ERRATA

## 1.2 Geology

## 2.1 Introduction

FIGURE VI  
SEQUENCE OF PILLAR RECOVERY

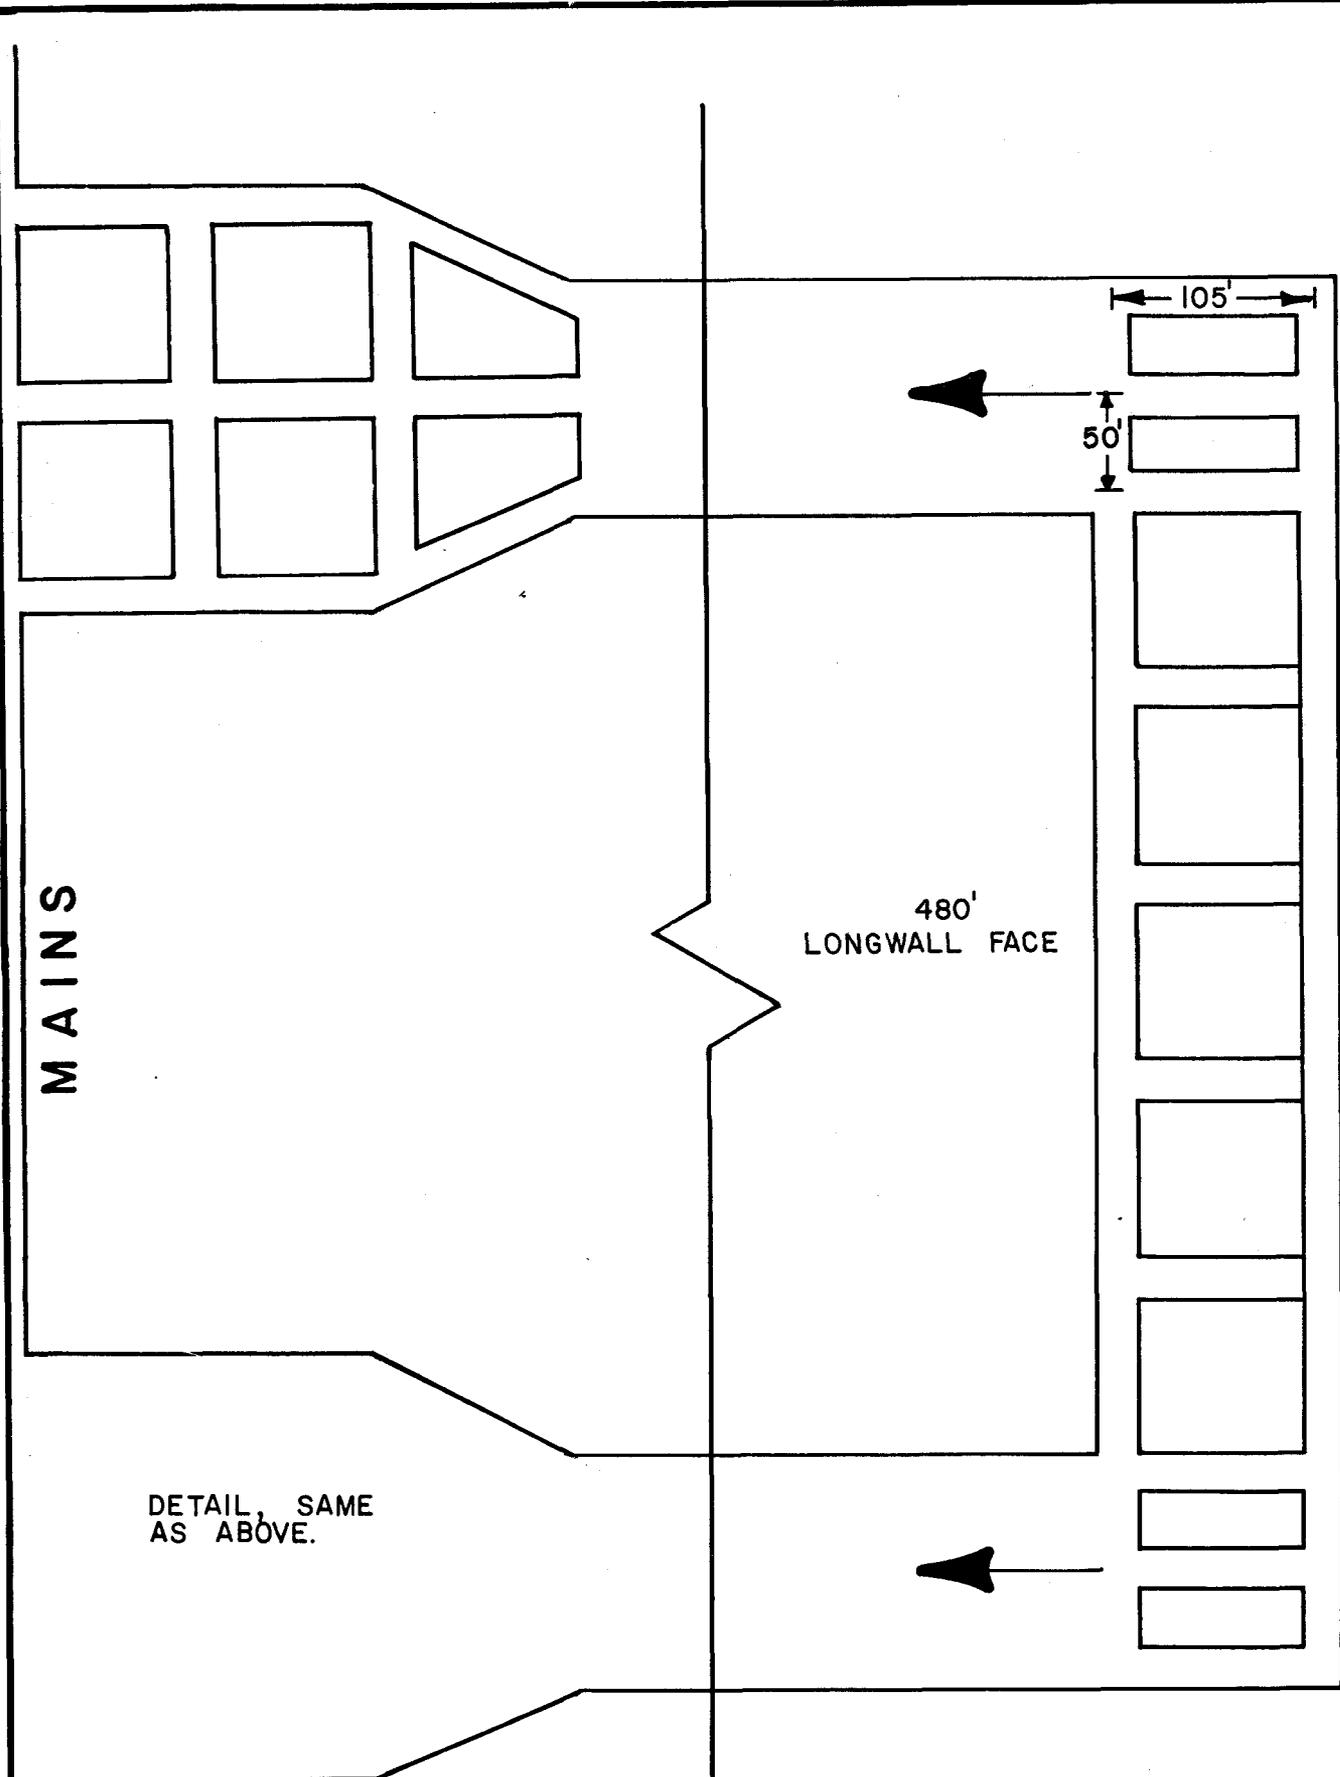
4. Replace Figure VI, Section 2 with new Figure VI, Sequence of Pillar Recovery and Typical Ventilation.
5. Replace Figure X, Section 2 with New Figure X, Typical Longwall Panel with Ventilation.

Pillars in Line A will be recovered first, starting at pillar #1 going to #6. Then the pillars in Line B will be recovered
